MONTGOMERY COUNTY HISTORIC PRESERVATION COMMISSION
STAFF REPORT

Address:	8000 Hampden Lane, Bethesda	Meeting Date:	2/7/2024
Resource:	Contributing Resource (Greenwich Forest Historic District)	Report Date:	1/31/2024
Applicant:	Chuen-Yen Lau & Adam Sherwat	Public Notice:	1/24/2024
Review:	HAWP	Tax Credit:	n/a
Permit No.:	1029531 REVISION	Staff:	Dan Bruechert
Proposal:	Revision to previously approved HAWP for alterations to previously approved garage

PROPOSAL

- THIN BRICK VENEER 
- SIDING 
- COPPER 
- SLATE

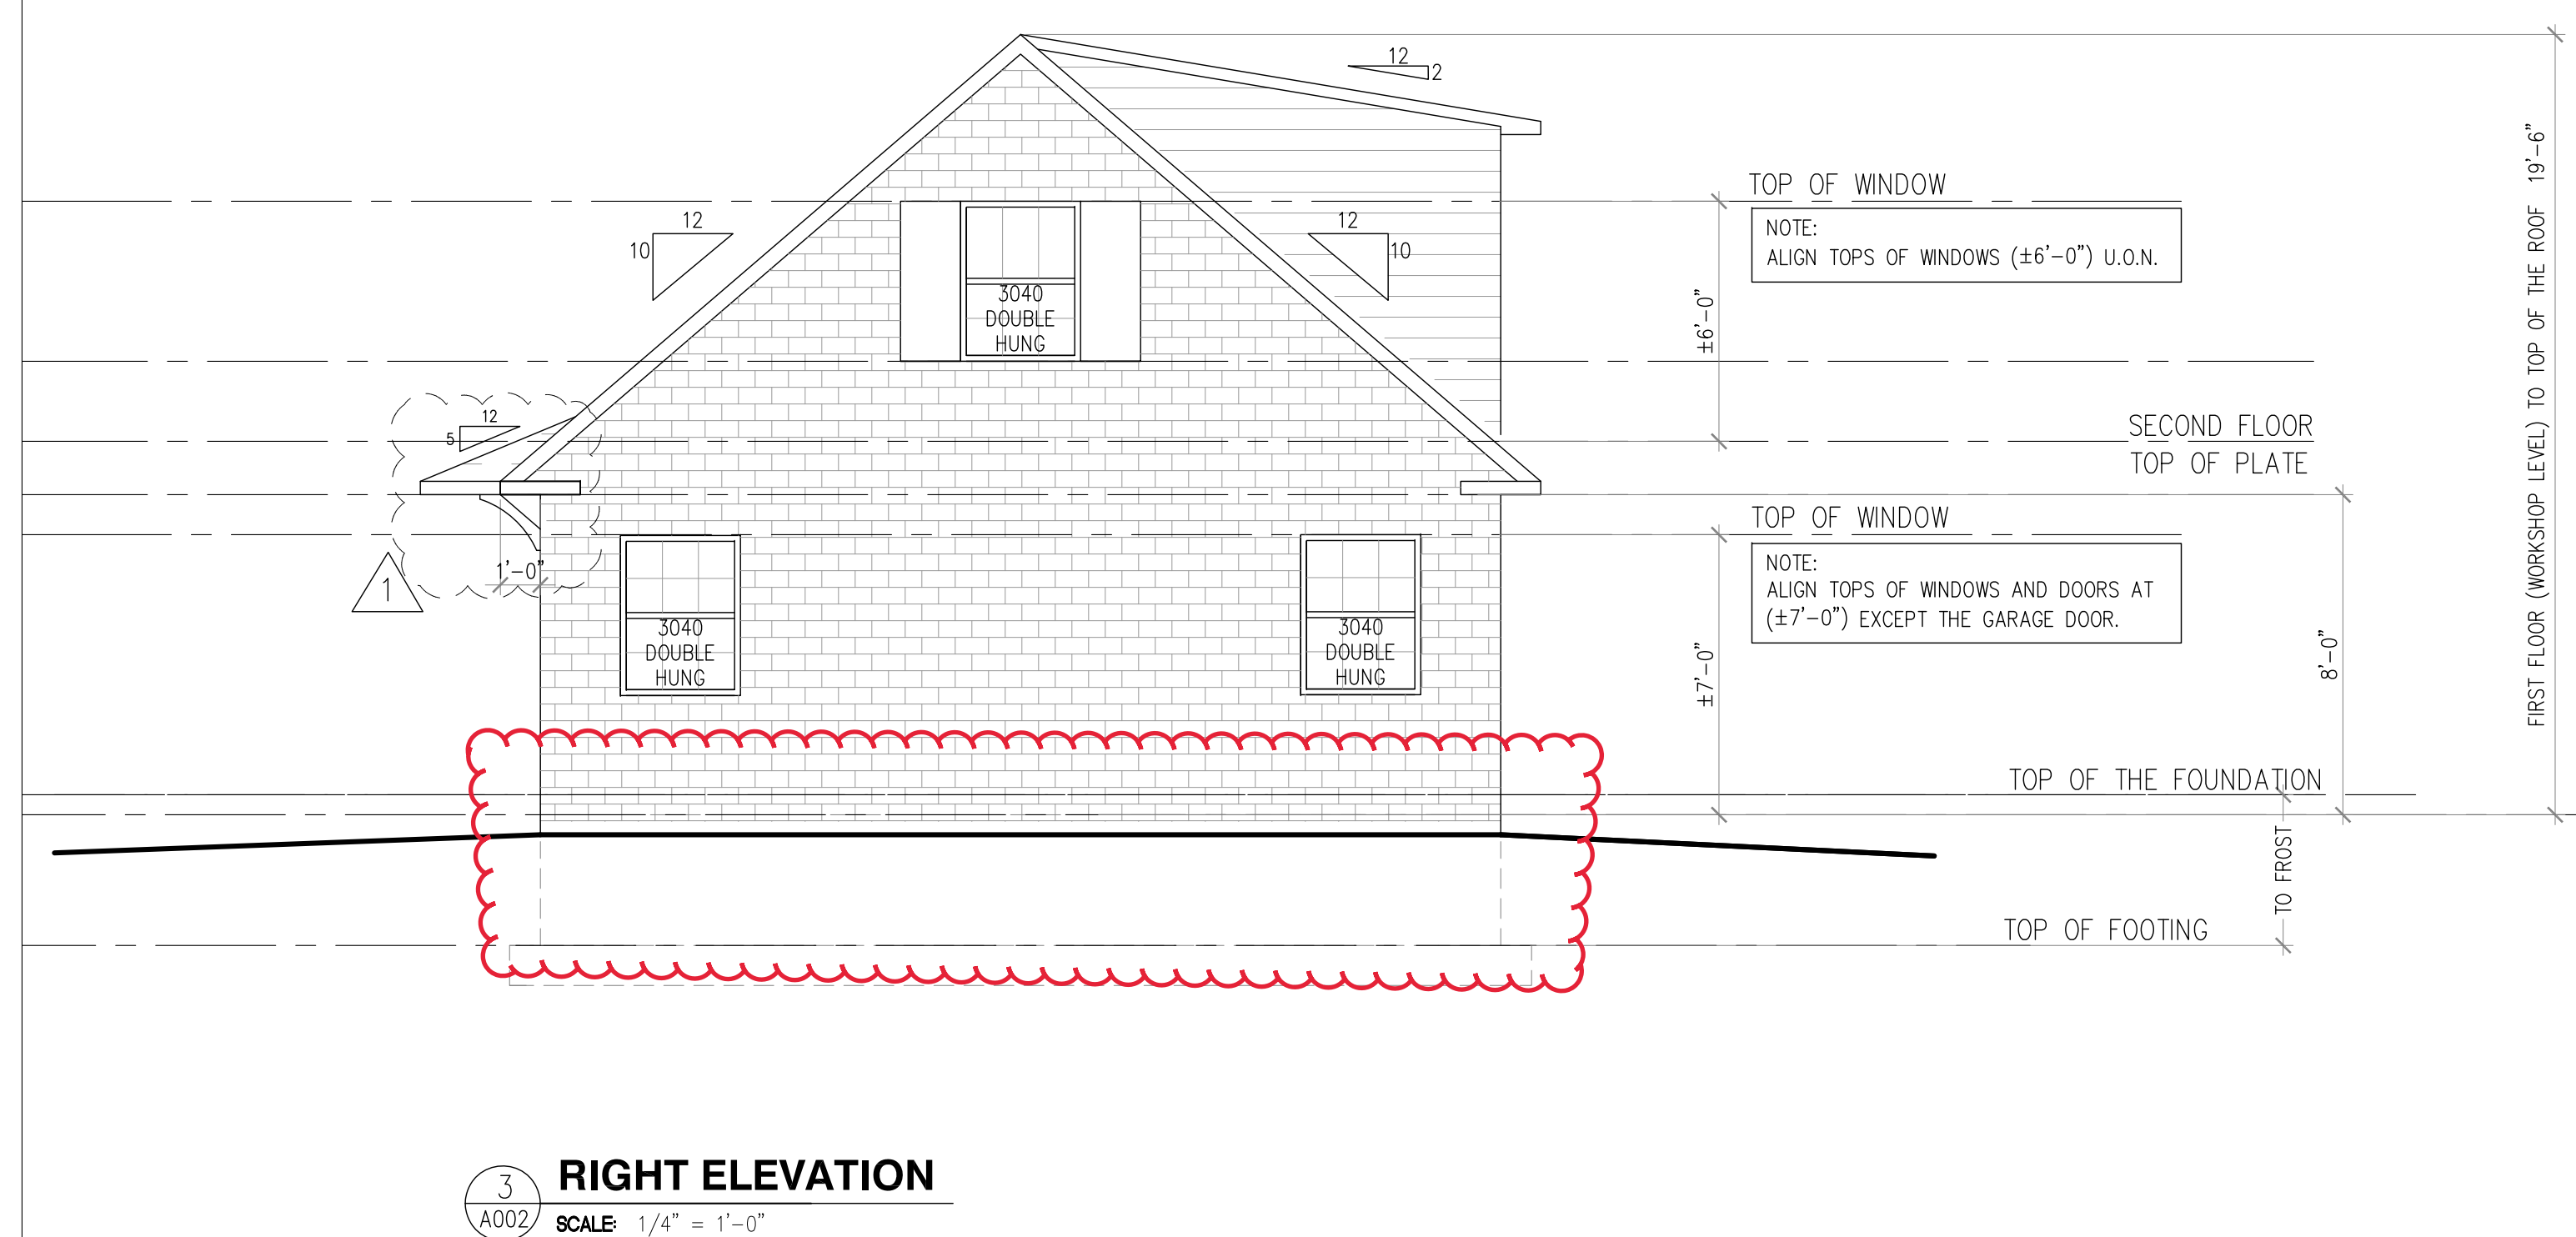
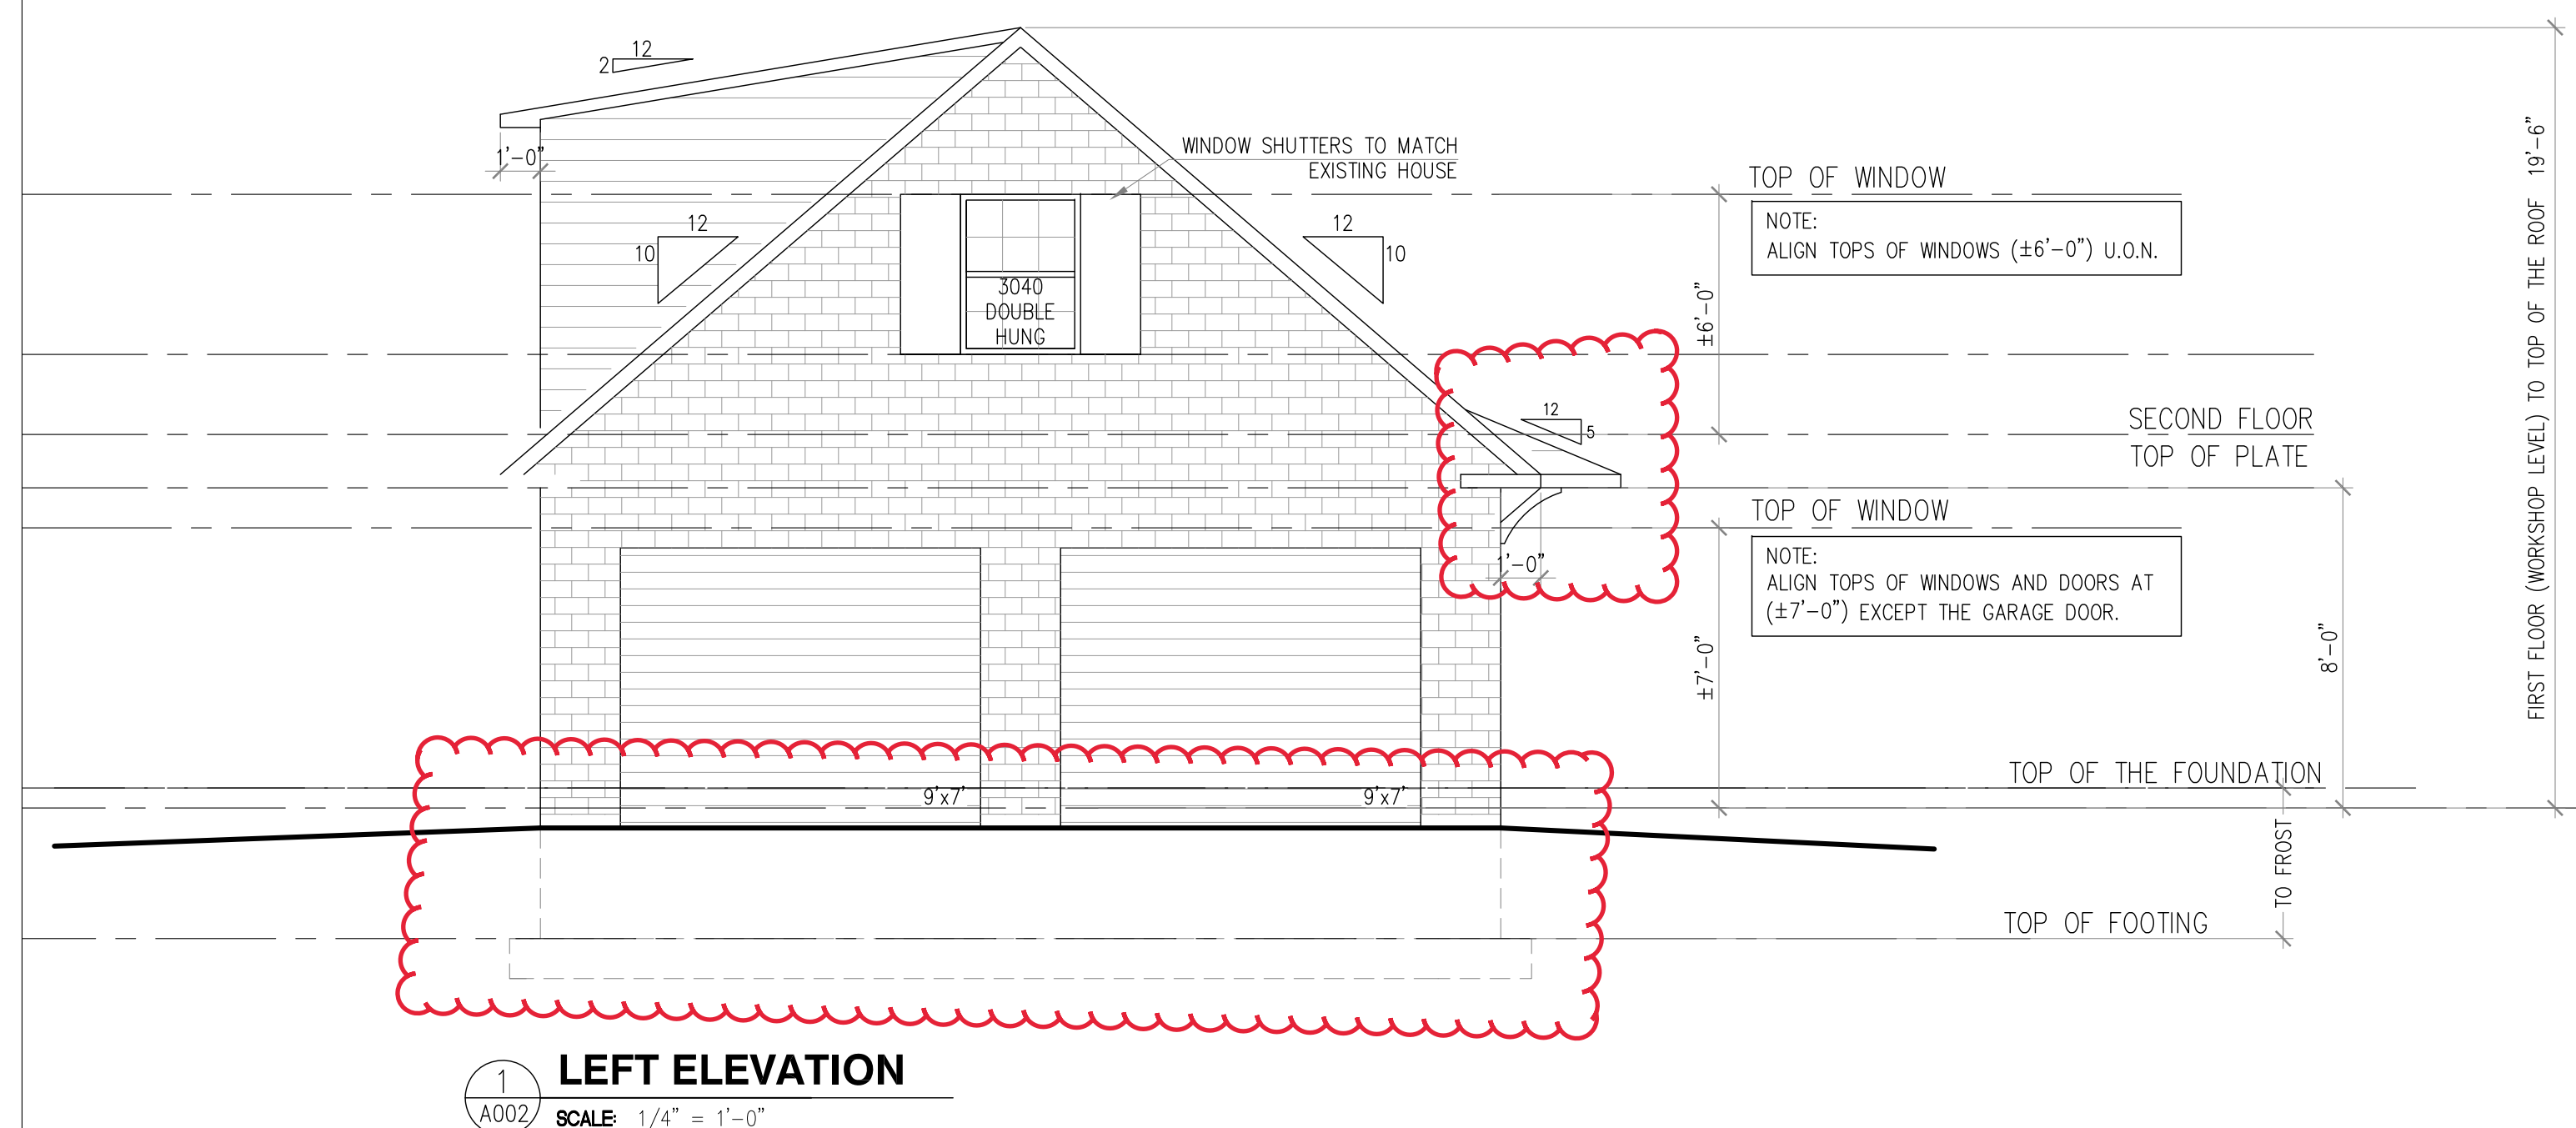
Foundation Material

The approved foundation material was stone to match the house foundation. The revised design has removed the decorative stonework and now proposes to carry the brick exterior to grade. Staff finds this change in materials still satisfies the requirement for ‘high-quality building materials’ as dictated by the *Design Guidelines*. Therefore, Staff recommends the HPC approve the new foundation material under the *Design Guidelines*, 24A-8(b)(2) and (d), and Standards 2, 9, and 10.

Roof Brackets

The HAWP approval showed no roof supports for the small roof above the pair of French doors on the front elevation. The revised design now includes simply detailed wood brackets on either side of pair of doors. Staff finds stylized wood brackets are found throughout the historic district in many of the Tudor Revival houses; and while none are on the subject property, Staff finds this to be a compatible feature and recommends the HPC approve the brackets under the *Design Guidelines*, 24A-8(b)(2) and (d), and

1	Brackets on each side of the door at the workshop shown on the right elevation.
---	---

SHEET TITLE:
Building Permit Site Plan

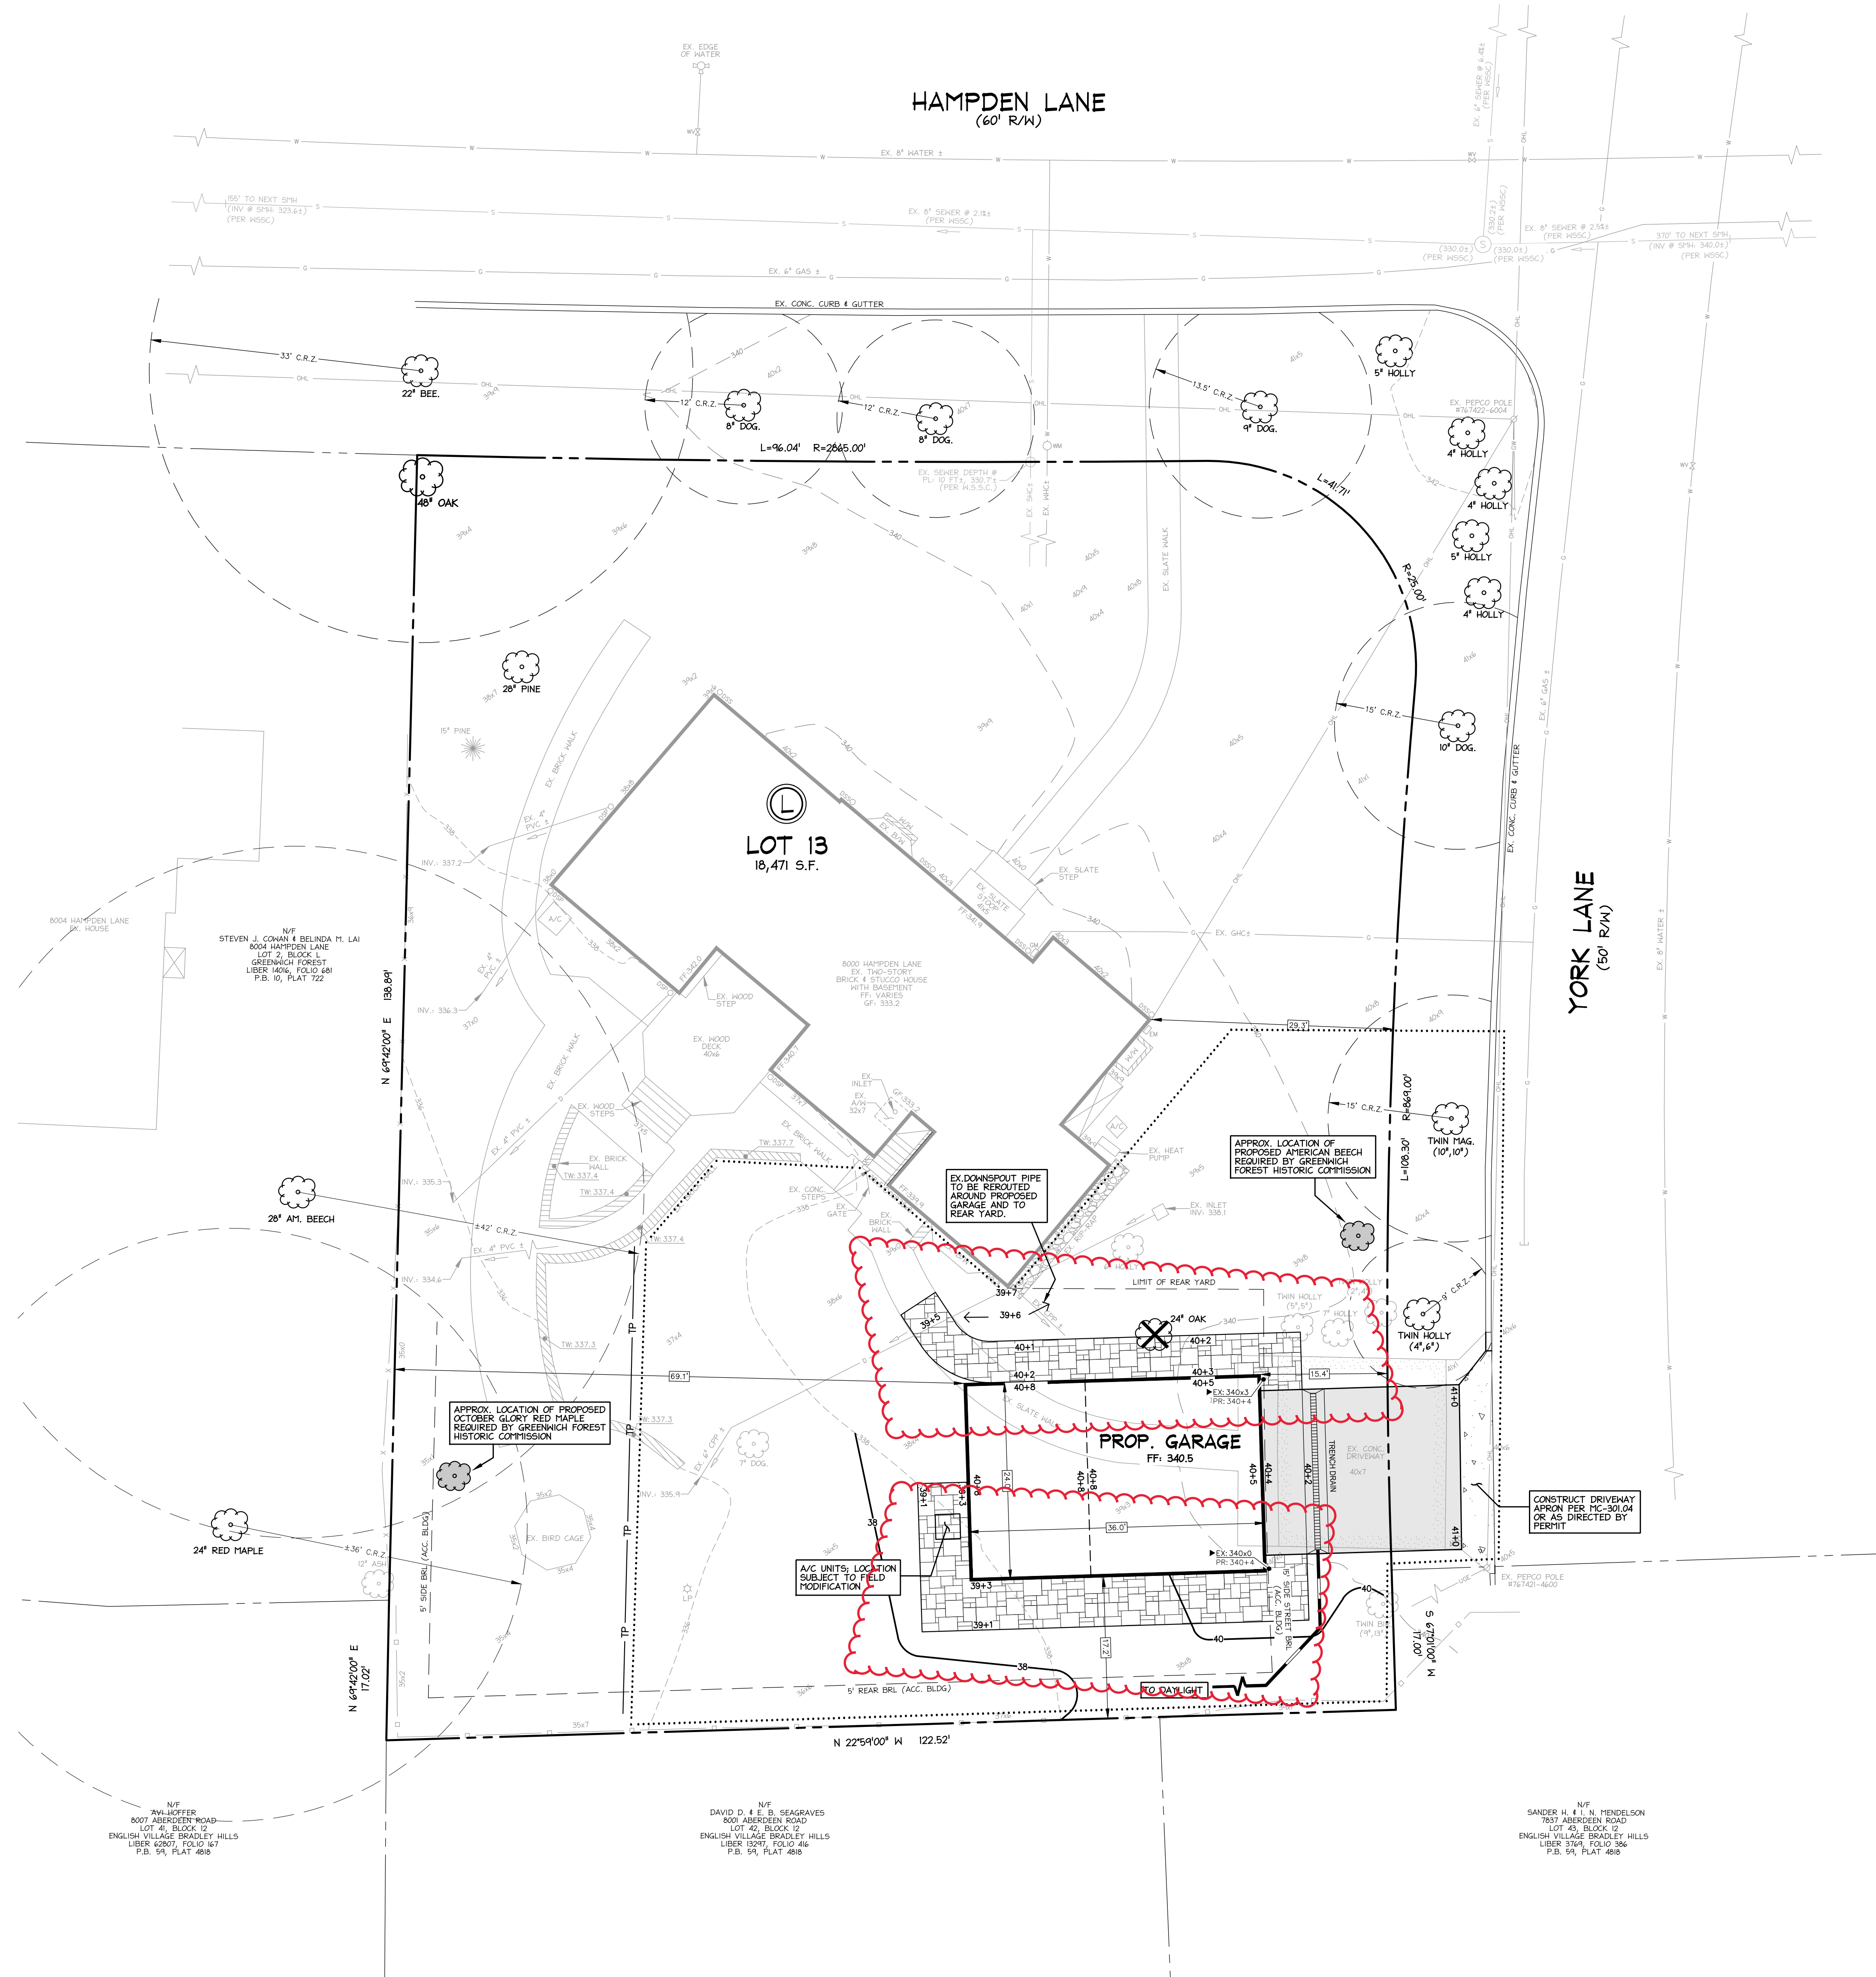
Hardscaping

On the front and rear sides of the garage, the applicant proposes to install a 2' (two-foot) wide walkway using variegated flagstones. The flagstones will connect to an existing walkway to the house. The previous approval did not include any paving.

The *Design Guidelines* state that new paving for walkways and patios should be ‘minimized’ to limit the total amount of impervious surface. Staff does not find the proposed walkways to be out of character nor does Staff find the walkways are larger than necessary. Staff recommends the HPC approve the walkway under the *Design Guidelines*; 24A-8(b)(2) and (d); and Standards 2, 9, and 10.
